CORRIGENDUM- 08

PROJECT	:	3X800 MW PVUNL PATRATU TPP PHASE-1
PACKAGE	:	MILL REJECT SYSTEM (CONVEYOR TYPE)
ENQUIRY NO	:	PE/PG/PA1/E-5988/2018 DTD 28/06/2018
SUBJECT	:	DUE DATE EXTENSION

**AMENDMENT ON TECHNICAL
SPECIFICATION FOR MILL REJECT
SYSTEM (CONVEYOR TYPE)
3X800 MW PATRATU STPP**

AMENDMENT 02

3X800 MW PATRATU STPP
MILL REJECT SYSTEM (LAYOUT FOR
UNIT-3

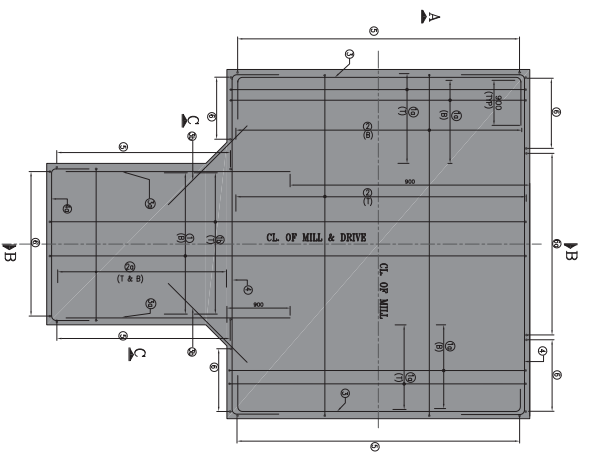
Sl. no.	Cl. No.	Existing Clause	Replaced By/Clarification
1	Section-1 /Sub Sec - 1A/Annexure-X/ Page-278 of 465	Layout Drawing of MRS	Orientation of Mill have been revised. Revised layout drawing incorporating conveyor length is attached. Note: There shall be no implication for change in the length of Conveyor up-to 5M. Preliminary Mill Foundation detail is attached for reference.
2	SECTION - I/Sub Section – IA/Cl.No.3.03.00 (14)/Page no.55 of 465	800 mm walkway along both sides of conveyor for Maintenance shall be provided in the tunnel.	Clear space of 800 mm is required on both sides of conveyor in the layout.
3	SECTION - I/Sub Section –IA/ Cl.No.3.03.00 (14)/Page no.56 of 465	Belting :Suitable heat resistant and fire resistant belting shall be provided	Belting: Suitable heat resistant and fire resistant belting shall be provided. However, Chain Bucket Elevator in addition to belt type bucket elevator is acceptable subject to end customer approval during detail engineering.

FOUNDATION PLAN

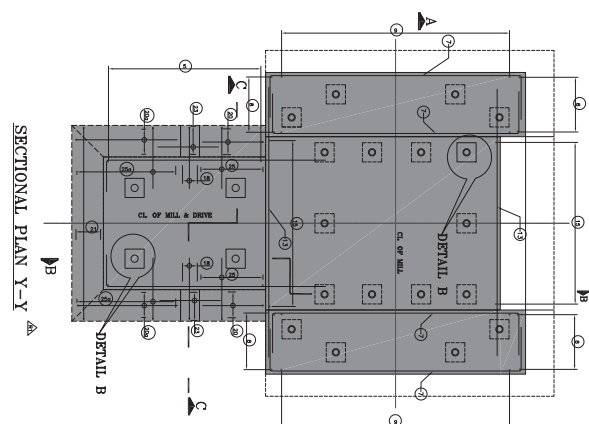
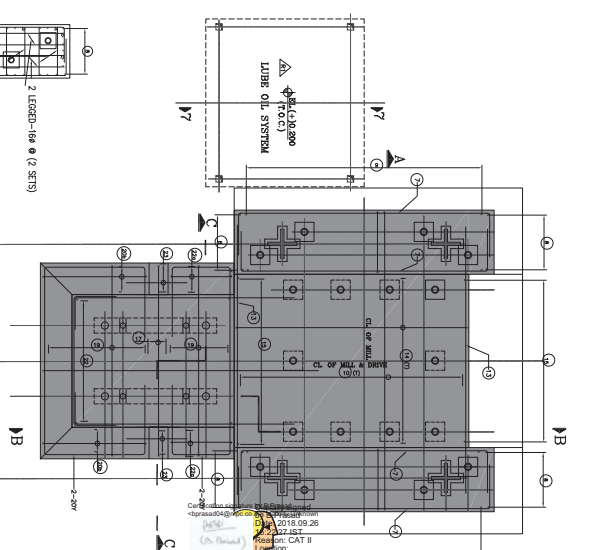
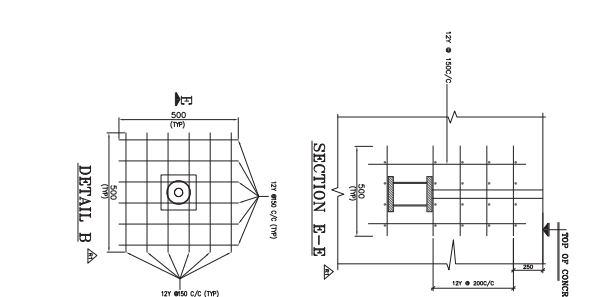
15	Corrigendum-06			Revised MRHS system layout	The silo locations/ distance & cross conveyor lengths are not mentioned . Kindly provide us a clear layout details (like silo location, mill foundastion, structure column foundation details)to consider accordingly.	Bidder to refer technical amendment no.-2. Column foundation details shall be furnished during detail engineering.
16	Corrigendum-06		Sl. No.1	Vibrating feeders, if required, can be electromagnetic or electromechanic or any other type, suitable for the said purpose.	If required and space/ design permits, small inclined chain conveyors will be considered in place of vibrating feeders . Kindly confirm.	Same shall be decided during detailed engineering
17		283 (2 of 2)	SL no 15	Any other equipment material/ service required for completeness of system based on system offered by the vendor (to ensure trouble free and efficient operation of the system).	Our scope is limited to field equipment to nearest JB. Control of the equipment shall be done from customer MCCI PLC. Refer attached P&ID.	Specification requirement is clear.The scope is limited to mill reject system as defined in the specification.
